Nuclear Operating Company
South Texas Project Electric Generating Station P.O. Box 289 Wadsworth, Texas 77483

April 14, 2010
U7-C-STP-NRC-100083

South Texas Project
Units 3 and 4
Docket Nos. 52-012 and 52-013
Supplemental Response to Request for Additional Information

Attachments 2 through 6 are revised or supplemental responses to NRC staff questions included in Request for Additional Information (RAI) letter numbers 297, 299 and 302 related to Combined License Application (COLA) Part 2, Tier 2, Sections 3.7 and 3.8. References 1 and 2 provided the original response to the following RAI questions:

Figure 03.07.01-24a: Comparison of Response Spectra, Reactor Building, Bottom of Basemat

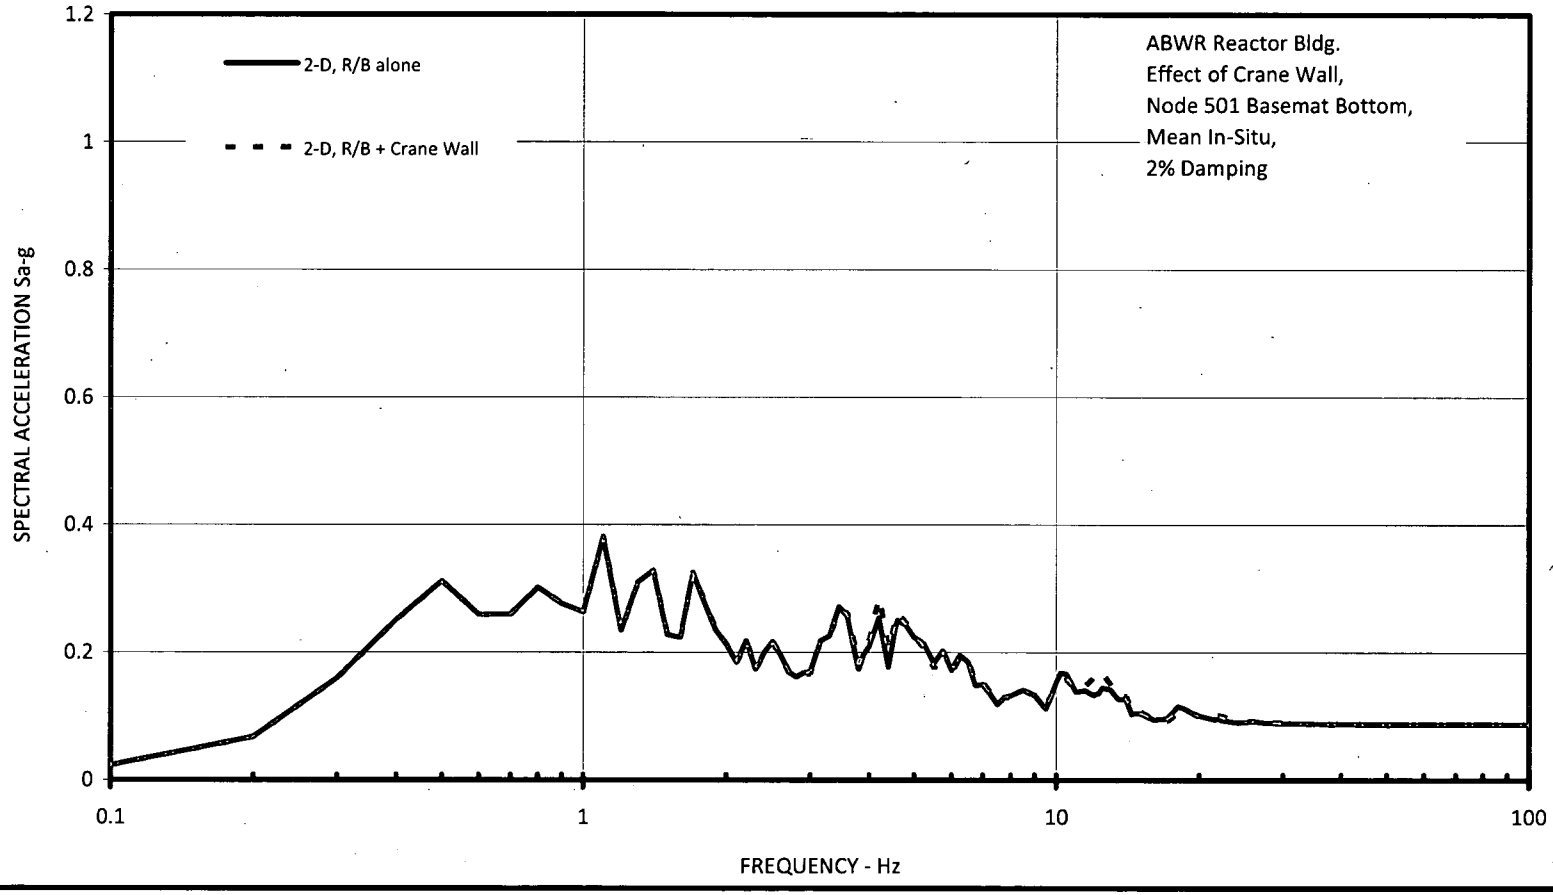
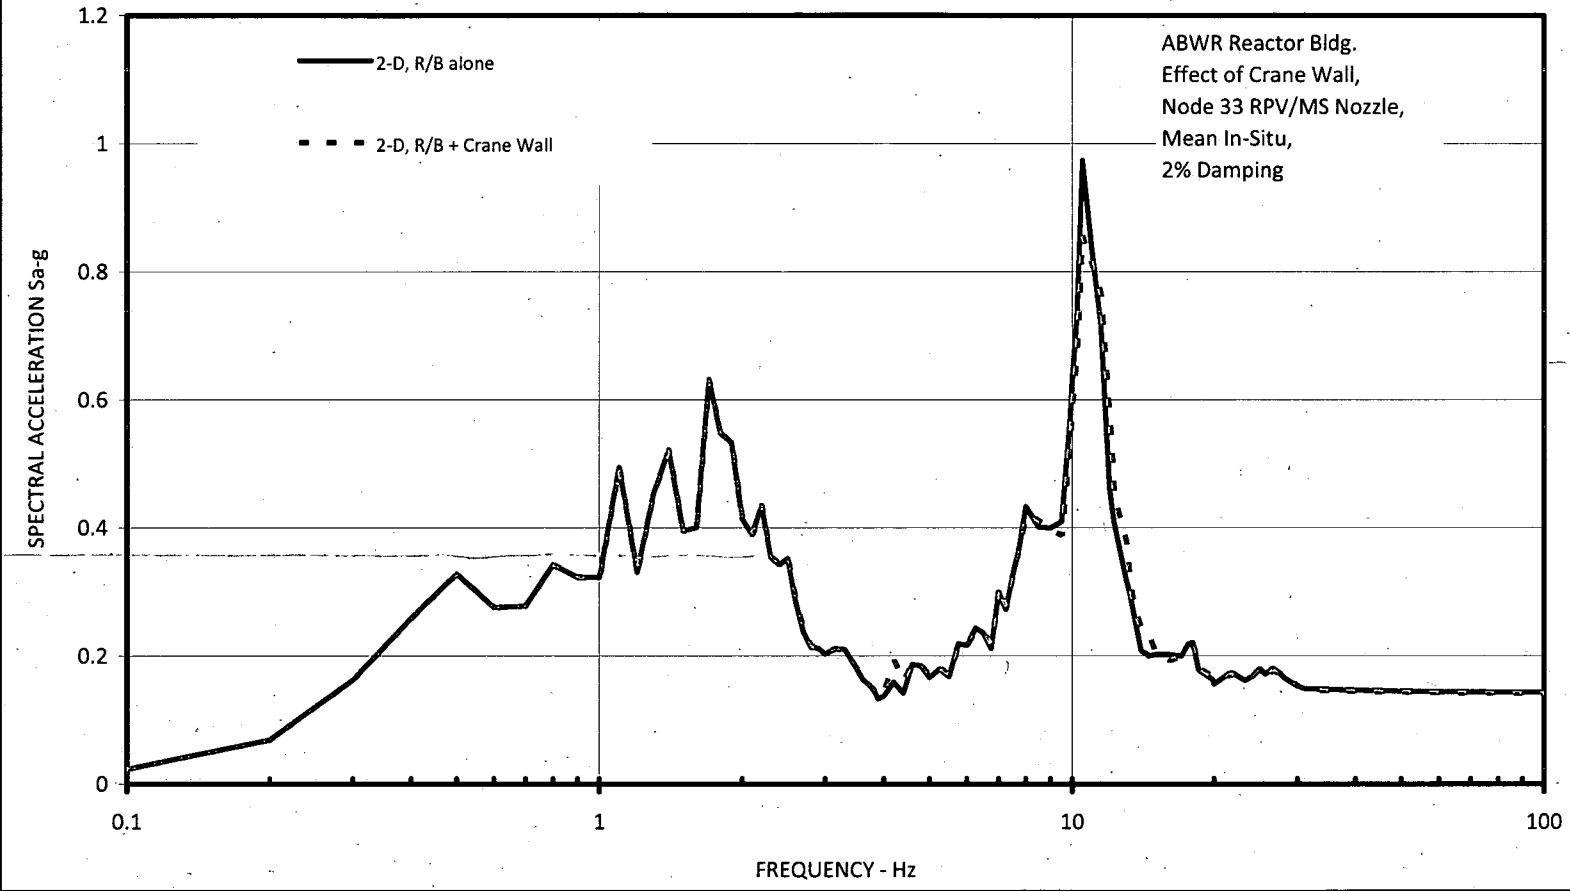
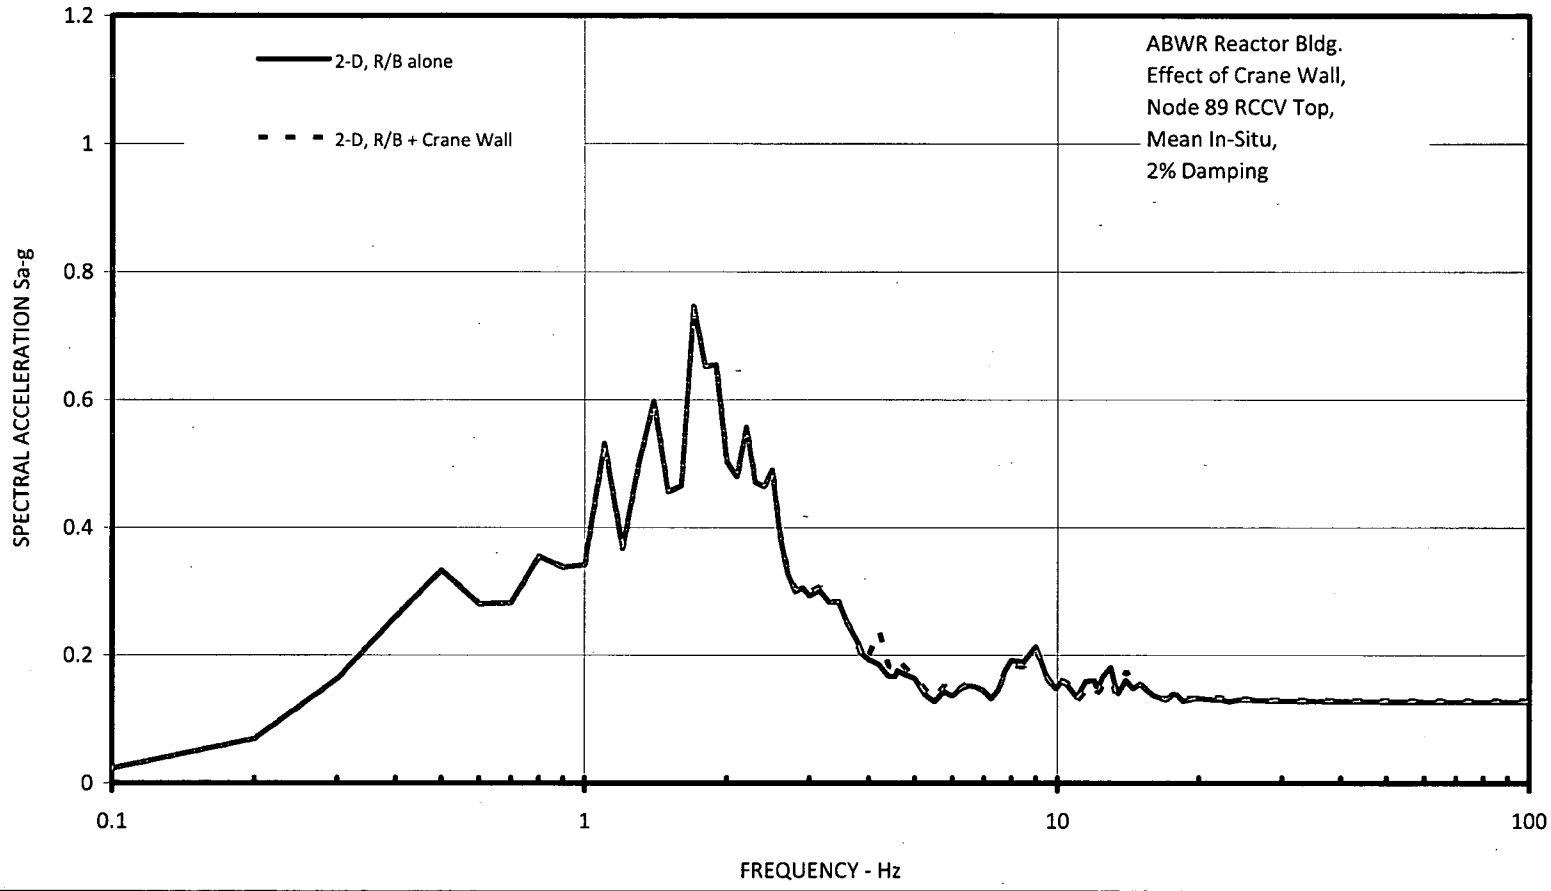
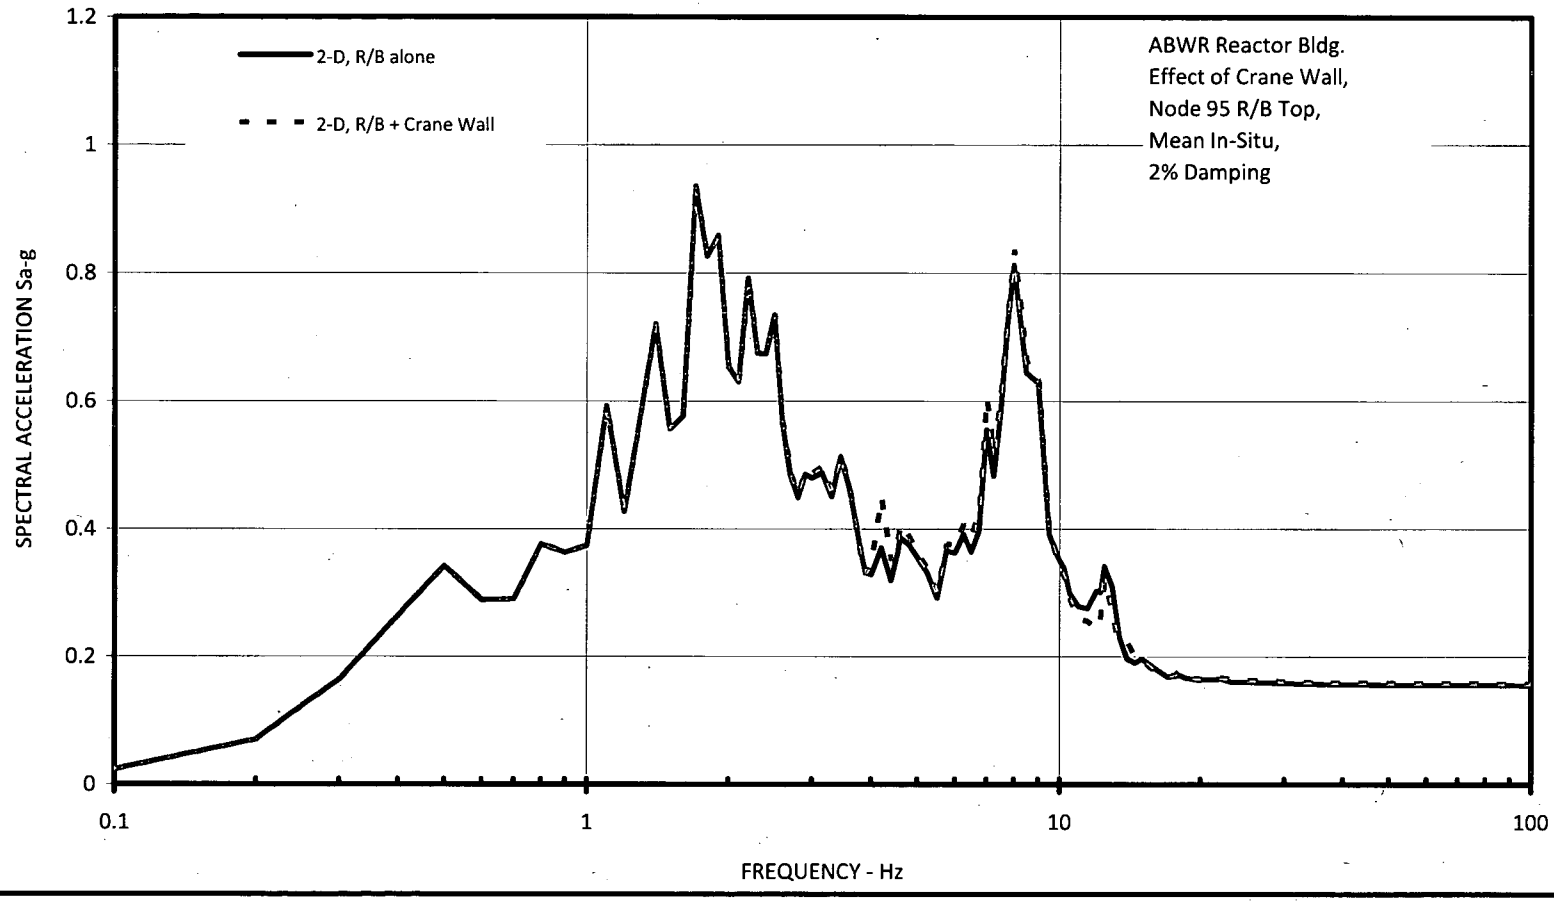
1. In the response to RAI 03.07.01-14, Item 1, the applicant cited DCD Appendix 3A in concluding that "... *the potential effect of structure-to-structure interaction was relatively small.*" However, DCD Section 3A.9.7, "Effect of Adjacent Buildings" also concluded that seismic soil pressure in between the RB and CB increased due to structure-to-structure interaction (SSSI) effect. As such the applicant is requested to discuss how the potential effects of increase in the seismic soil pressure in between the Category 1 structures and the retaining wall due to the SSSI effect has been addressed and bounded by the certified design.

2. In the response to RAI 03.07.01-14, Item 2, the applicant stated in the second bullet that "*In comparison to the Reactor, Control and Turbine Buildings, the retaining wall is a light structure and a lighter structure will have less influence on the seismic behavior of the heavy adjacent structures.*" While the inertia of the RC retaining wall is not expected to affect the seismic response of the adjacent seismic Category I structures, the stiff retaining wall can act as a barrier to reflect the seismic waves due to kinematic interaction with surrounding soil and could affect the seismic input to the adjacent structures. As such, the applicant is requested to provide a quantitative assessment of the effect of RC retaining wall on the SSI analysis of adjacent Reactor and Control Buildings.

In order to address the above two questions, a soil-structure interaction (SSI) analysis of the Reactor Building (RB) and Control Building (CB), with and without the crane wall, was performed for the site-specific conditions, including site-specific safe shutdown earthquake (SSE) and soil properties. These analyses were performed using two-dimensional (2D) models of the RB and CB. The SSI analyses were performed using the SASSI2000 program. Summaries of the SSI analyses results for the mean soil case are presented below. Similar results are obtained for lower and upper bound soil cases.

- Table 03.07.01-24a compares the maximum forces and moments, at key locations of the RB, with and without the crane wall. As can be seen, the crane wall has a negligible effect on the resulting maximum forces and moments.
- Figures 03.07.01-24a through 03.07.01-24d provides comparisons of response spectra at several locations with and without the crane wall. As can be seen, the crane wall has a negligible effect on the resulting spectra.
- Figure 03.07.01-24e provides the comparison of the resulting seismic soil pressures from the SSI analyses with and without the crane wall. As expected, these seismic lateral soil pressures are significantly bounded by the design seismic soil pressure per DCD Tier 2, Figure 3H.1-11 and pressure obtained from the alternate modified Ostadan method described in COLA Part 2, Tier 2, Section 2.5S.4.10.5.2.

Figure 03.08.01-8A DCD Pool Swell Load

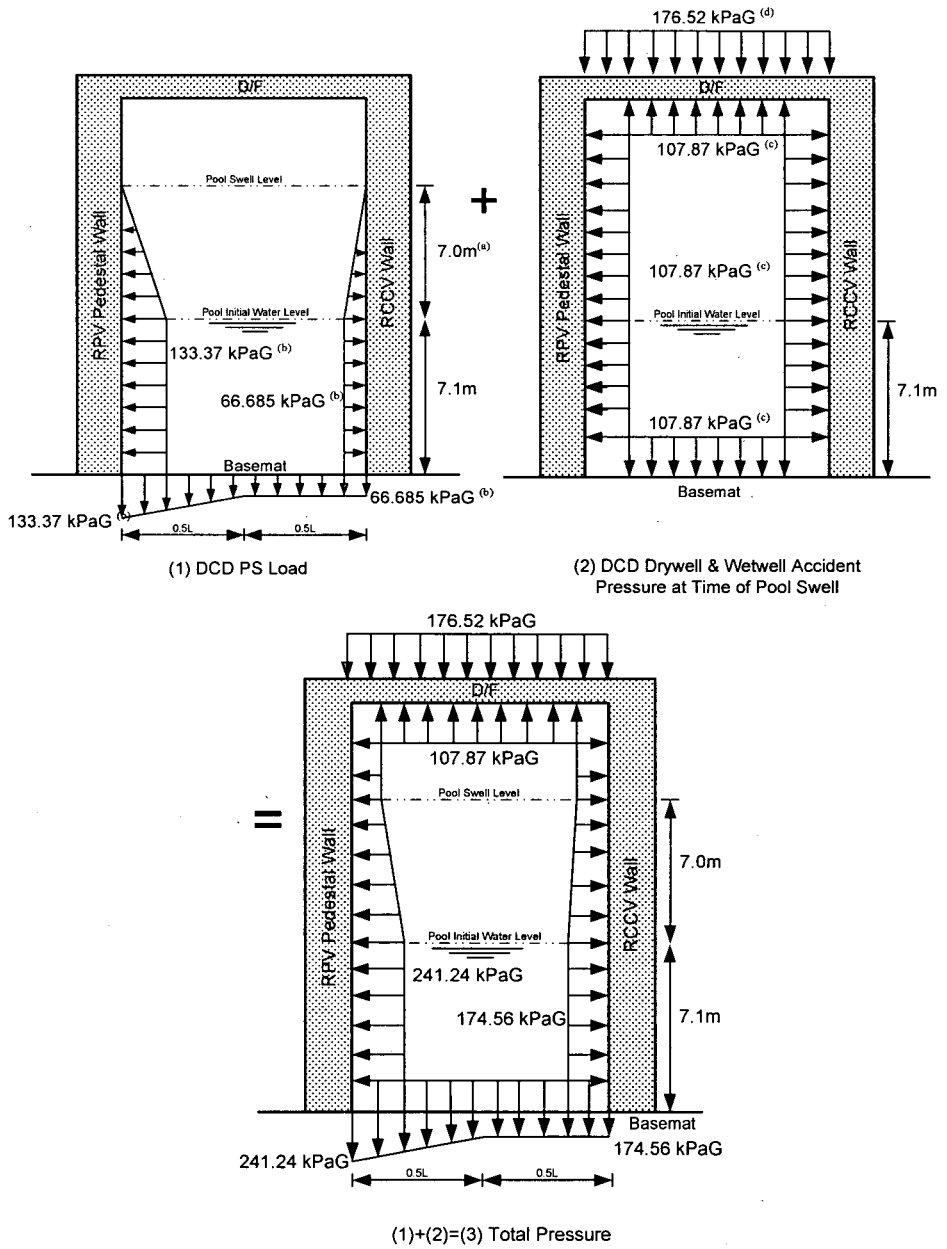
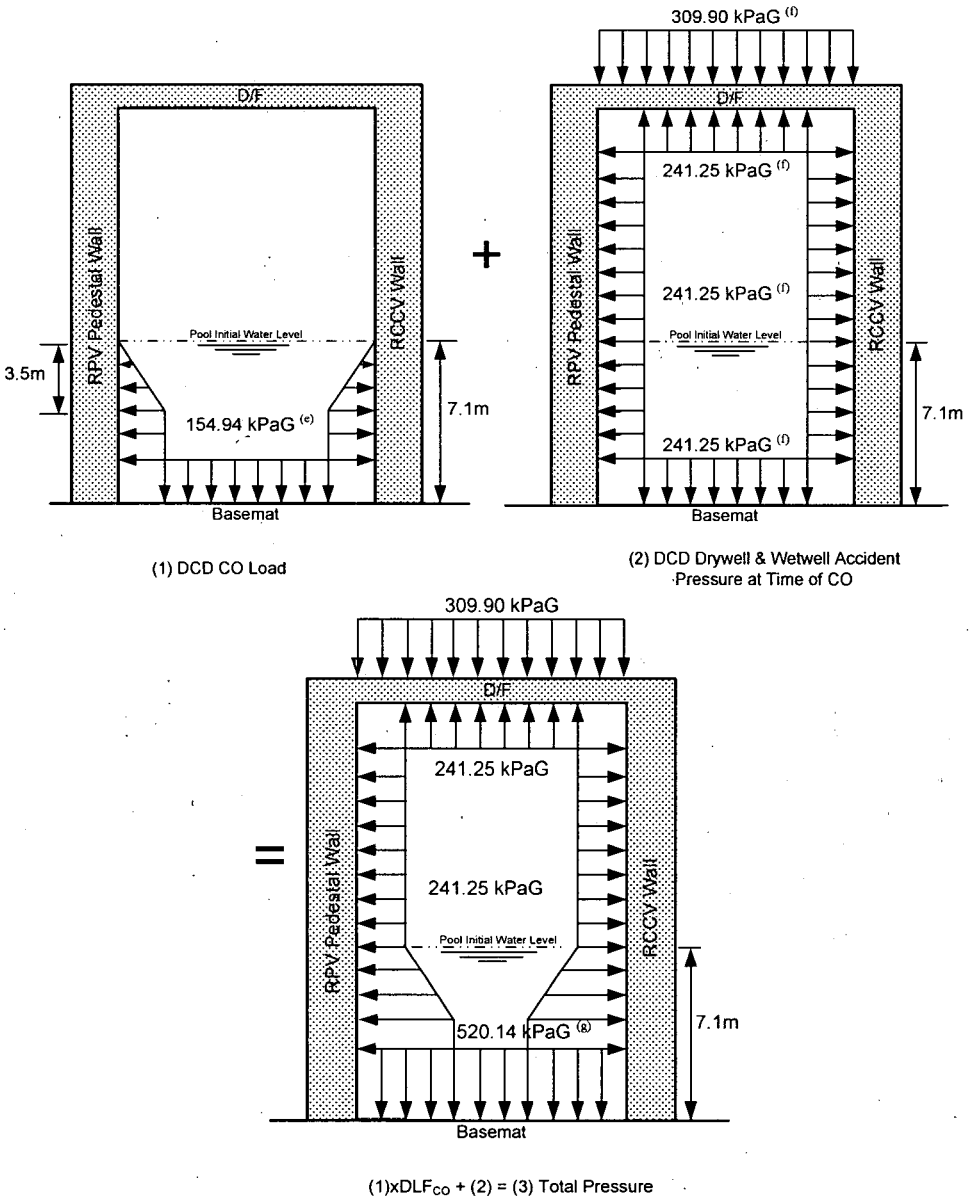
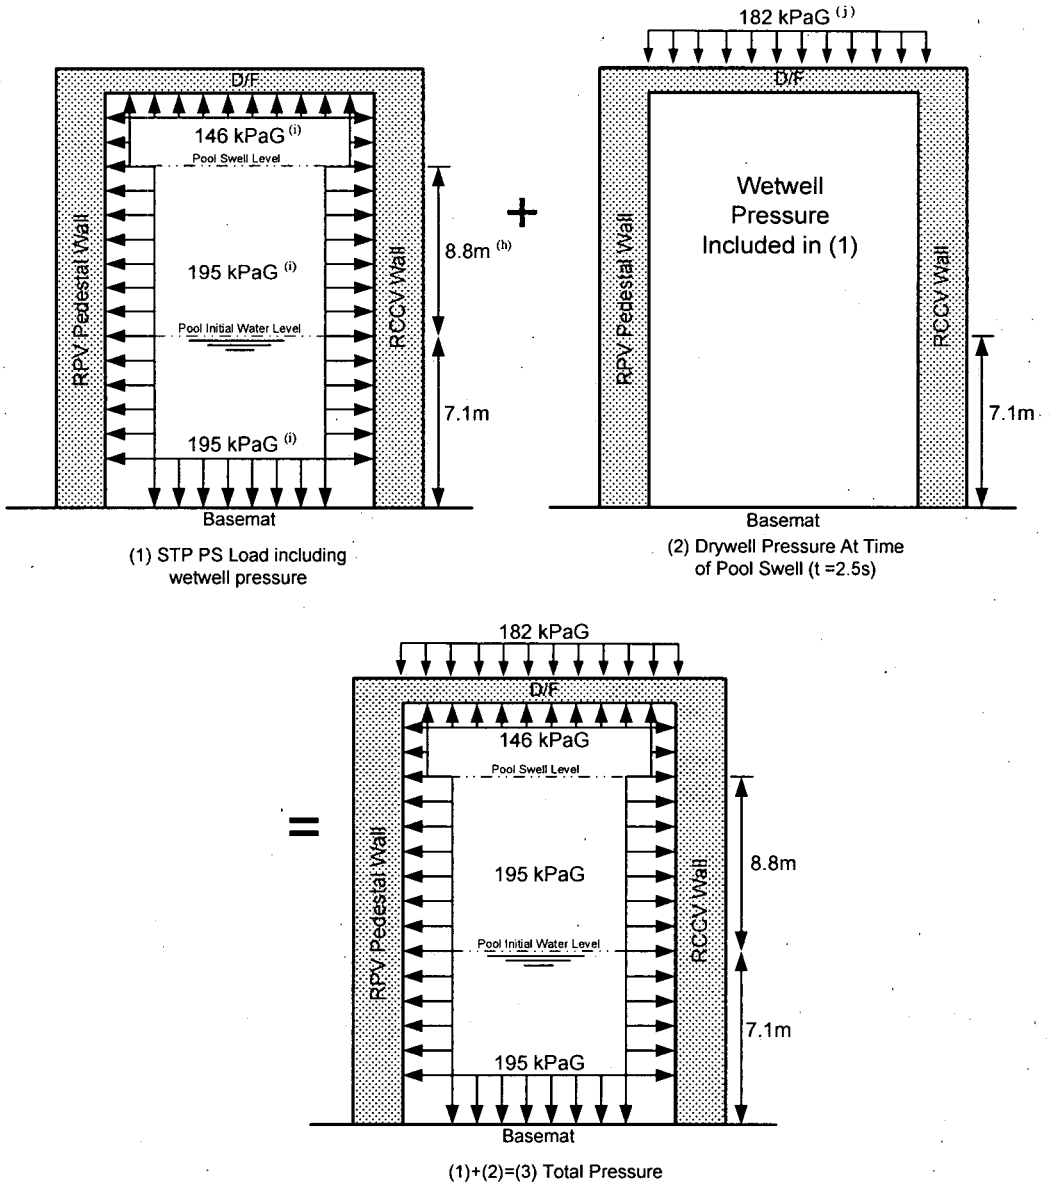
The applicant's response to Question 03.08.01-5 states that the changes in loads on the containment internal structures due to the increase in pool swell height and pressure will be addressed during the detail design phase. However, ABWR DCD Subsection 3H.1.5.5.2 describes the design of the containment internal structures, load combination (including pool swell loads), and analysis and design results. These are incorporated by reference in FSAR Section 3H. Also, pool swell loads are used in loading combinations for design of the containment structure, and analysis and design results for the containment structure are reported in Appendix 3H. Since the changes in loads due to increases in pool swell height and pressure on the concrete containment and containment internal structures are not addressed at this time, the applicant is requested to provide a quantitative evaluation and confirm that the increased pool swell height and pressure will not have an adverse impact on the design of the concrete containment and the containment internal structures, and that it is appropriate to incorporate by reference the analysis and design results for the containment and the containment internal structure reported in Appendix 3H of ABWR DCD.

The effect of increased pool swell (PS) height and pressure has been evaluated. The results of the evaluation confirm that the increased pool swell height and pressure will not have an adverse impact on the design of the concrete containment and the containment internal structures, and that it is appropriate to incorporate by reference the analysis and design results for the containment and the containment internal structure reported in Appendix 3H of the ABWR DCD. The design of the Reinforced Concrete Containment Vessel (RCCV) and internal structures, as described in ABWR DCD Section 3H.1.5, considered selected load combinations as delineated in ABWR DCD Tables 3H.1-5a and 3H.1-5b. In these load combinations, Condensation Oscillation (CO) was considered to be the controlling loss-of-coolant accident (LOCA) (CO, Chugging (CH), or PS) load, as these three LOCA loads do not occur simultaneously. For the containment and containment internal structures described in ABWR DCD Sections 3H.1.5.5.1, 3H.1.5.5.2, and 3H.1.5.5.3, the load combinations including CO + Pa (Pa is the containment pressure associated with the LOCA) loads governed over the load combinations including PS + Pa loads, as shown in Figures 03.08.01-8A (which shows the magnitude and distribution of the DCD PS and Pa loads) and 03.08.01-8B (which shows the

magnitude and distribution of the CO and Pa loads). It has been concluded that the load combinations including CO + Pa loads still govern over the load combinations including the revised PS + Pa loads, as shown in attached Figures 03.08.01-8B and 03.08.01-8C (which shows the magnitude and distribution of the revised PS and Pa loads). A summary of the comparison, based on the data from Figures 03.08.01-8A through 03.08.01-8C, is included in the table below:

(All units kPaG)	Based on DCD PS and CO Loads		Based on Revised PS Load
	PS + Pa	CO + Pa	PS + Pa
Diaphragm Floor differential pressure	69 (conservative)	69	36
Reinforced Concrete Containment Vessel (RCCV) wall pressure	108 to 175	241 to 520	146 to 195
Reactor Pressure Vessel Pedestal pressure	108 to 241	241 to 520	146 to 195
Basemat pressure	175 to 241	520	195
